**HORIZON®. HRZ-D MANUAL**  
**ADDENDUM**  
June 1980

ADDENDUM to: HRZ-D MANUAL, REVISION\_1

JUNE 4, 1980

PARTS LIST CHANGES

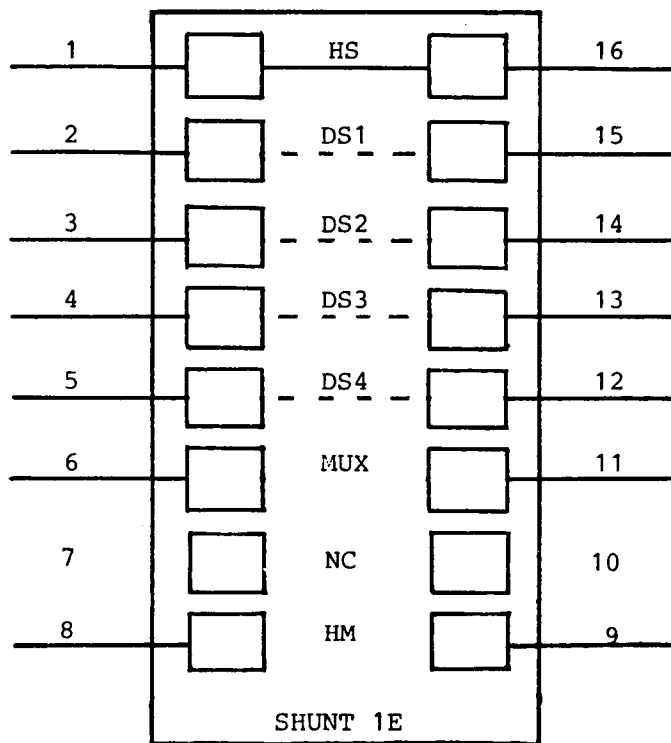
- A. On page 12, in the section titled DISK SUB-SYSTEM (MDS-H) PARTS LIST, delete two .047uf ceramic capacitors from the parts list.
- B. On Page 13, in the section titled SECOND DISK DRIVE (HRZ-DRV) PARTS LIST, delete two .047uf ceramic disc capacitors from the parts list.

- A. On page 37, delete instruction D1 in the section titled DISK DRIVE #1 POWER REGULATION ASSEMBLY.
  - B. On page 38, delete instruction E1 in the section titled DISK DRIVE #2 POWER REGULATION AND CABLE ASSEMBLY.

HORIZON MOTHERBOARD HRZ-MB-4	SHT
CLOCKS/COUNTERS	2 OF 5
© 1977, NORTH STAR COMPUTERS, INC.

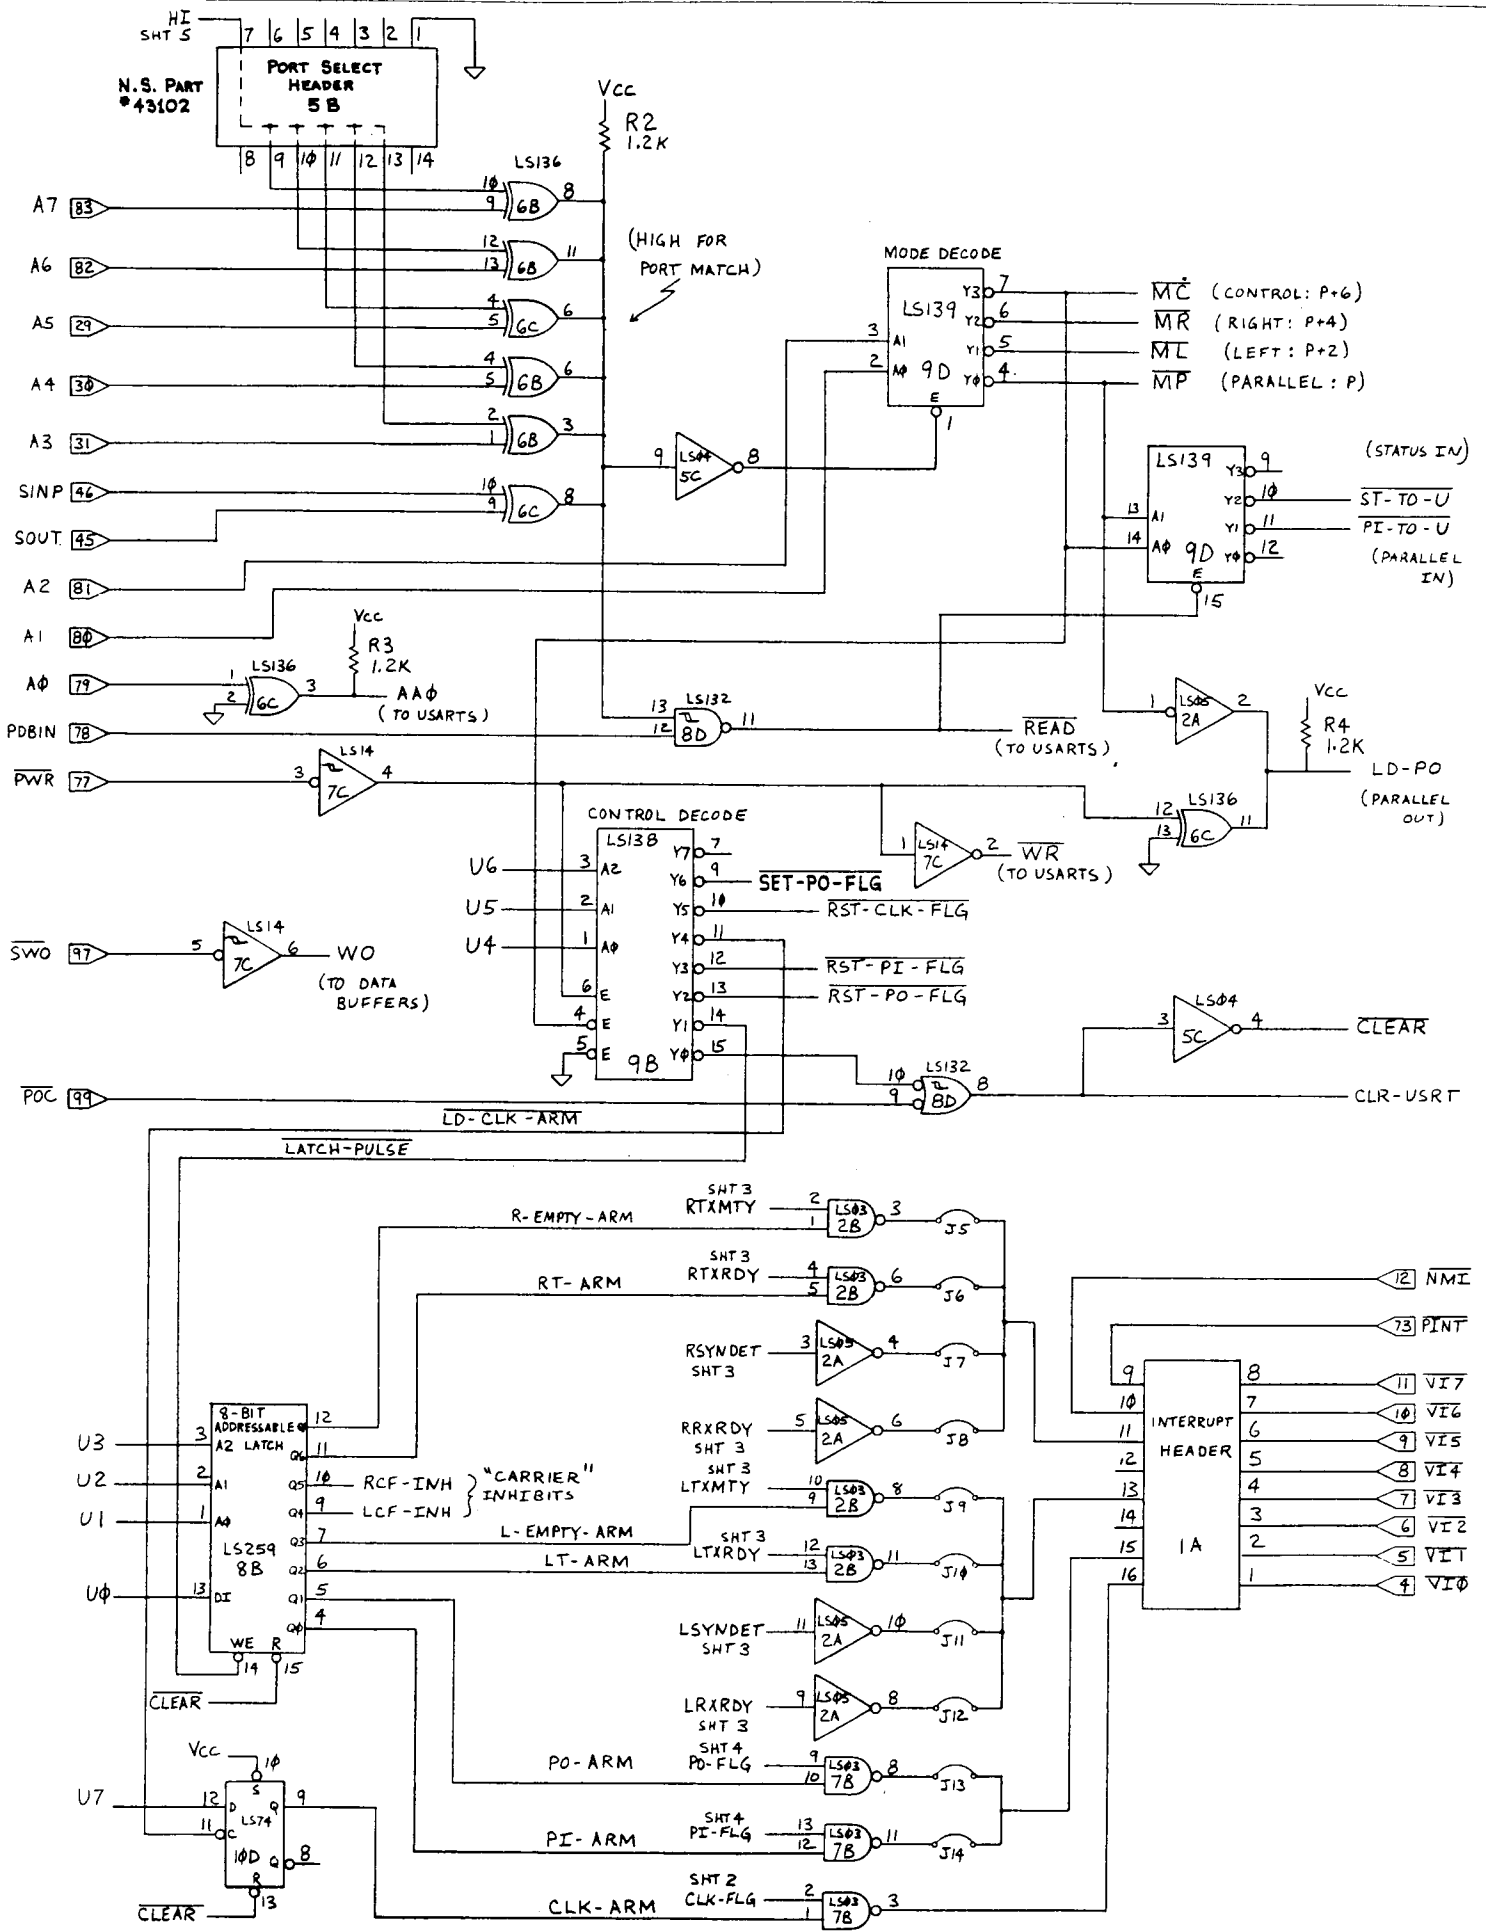
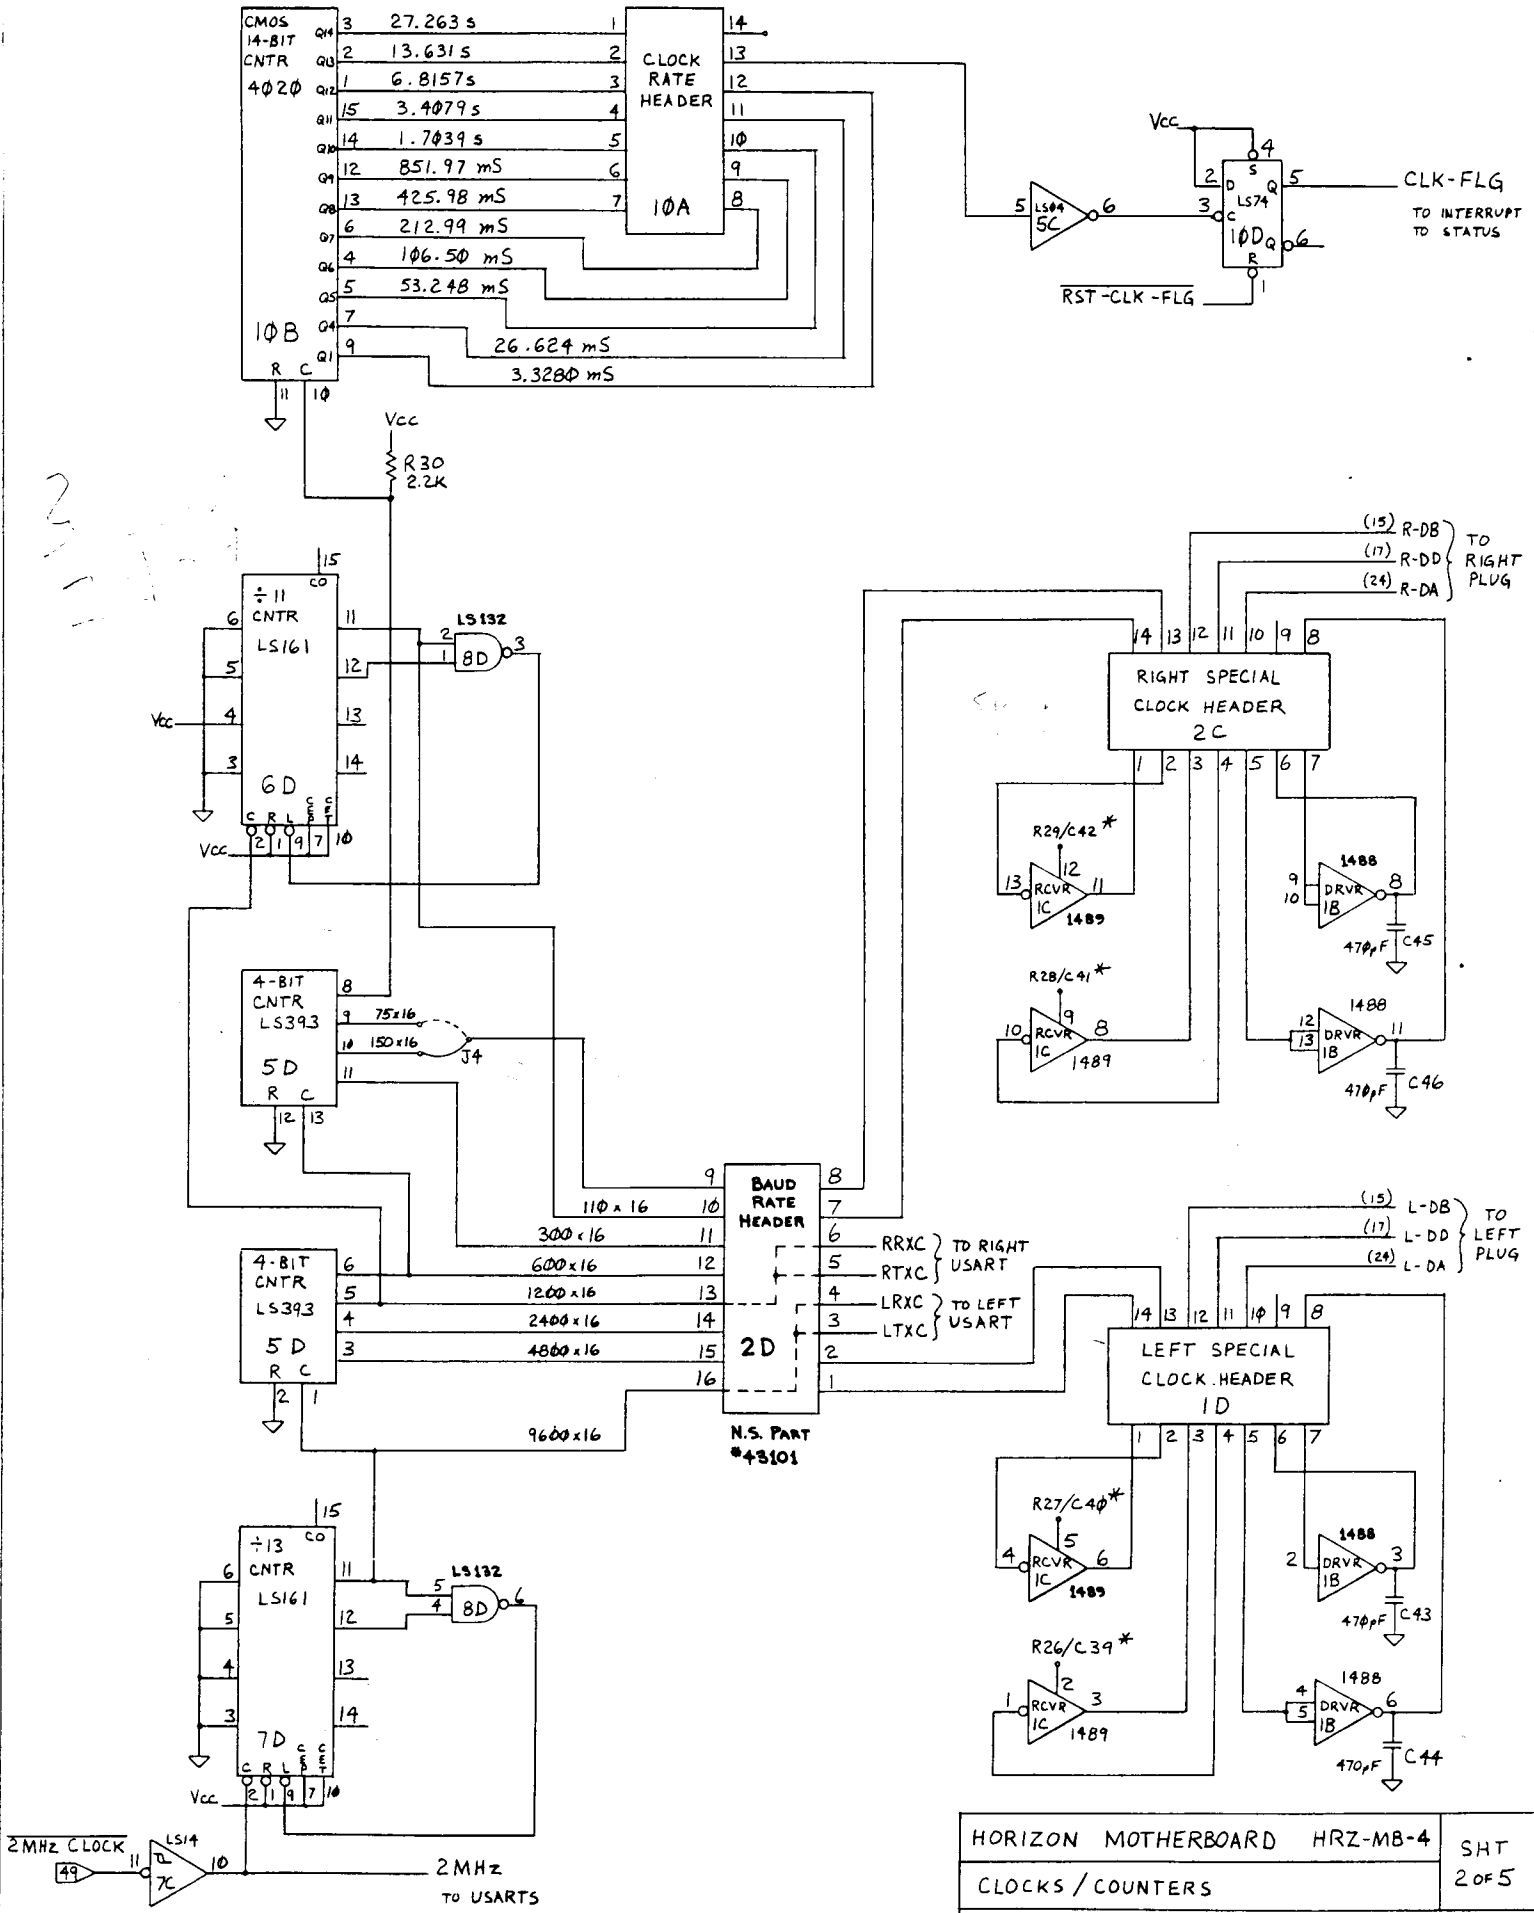
11) For all HORIZON Computer Systems containing motherboards marked "HRZ-MB-4", the following five pages of schematic drawings supersede pages 88, 89, 91, and 92 of the HORIZON Manual.

HORIZON MOTHERBOARD HRZ-MB-4	SHT
SERIAL PORTS	3 OF 5
© 1977, NORTH STAR COMPUTERS, INC.

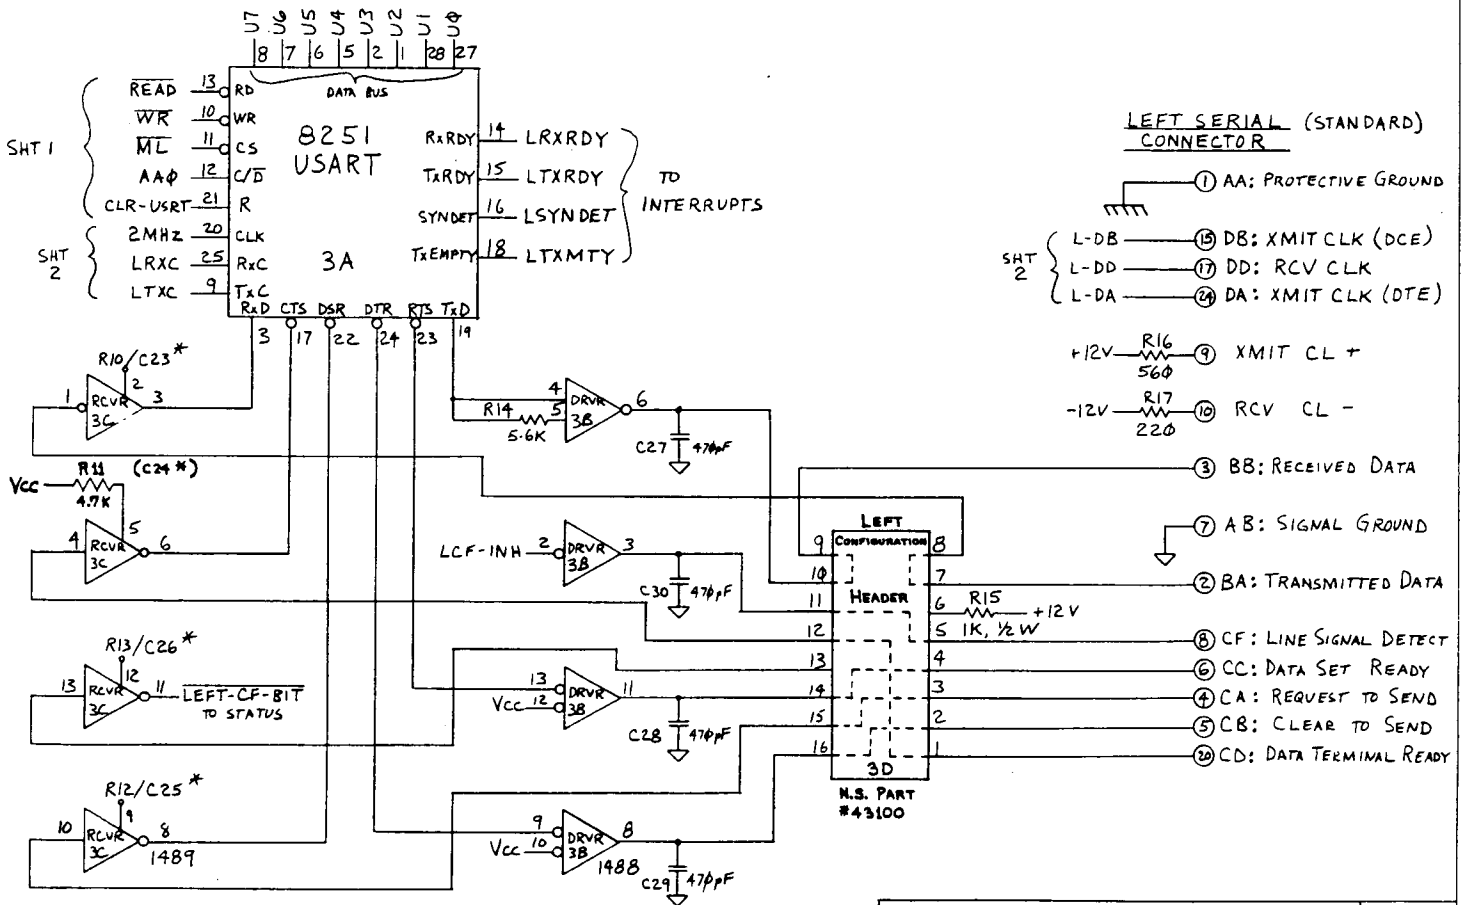
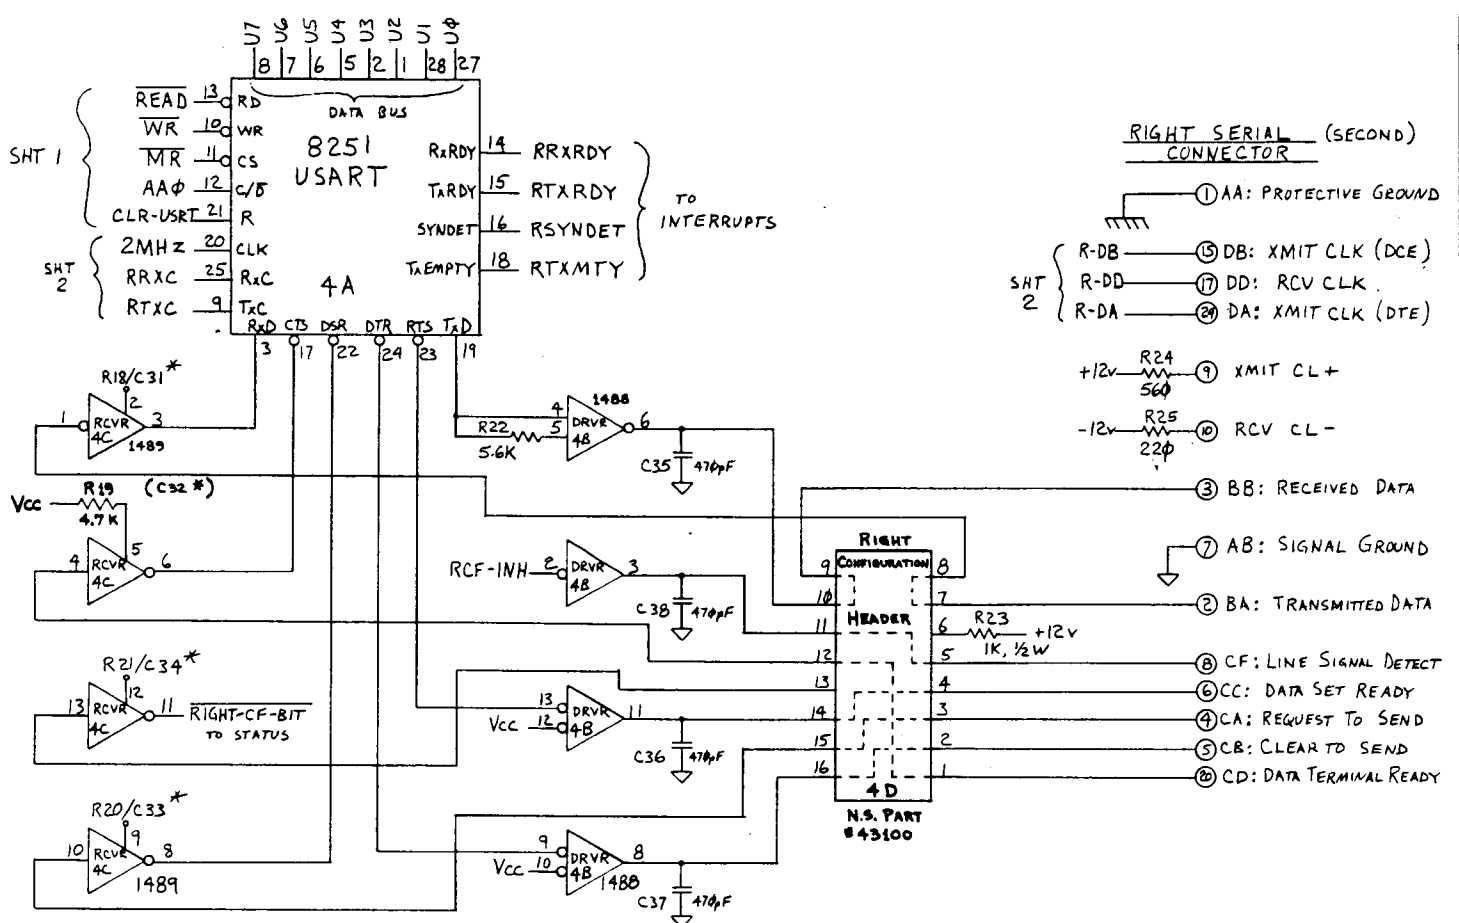
\* NOTE: TO EACH RS232 RECEIVER (12 PLACES), USER MAY ADD RESISTOR TO Vcc OR CAPACITOR TO GND. (4.7K RESISTOR NOMINALLY INSTALLED AT PIN # 5)
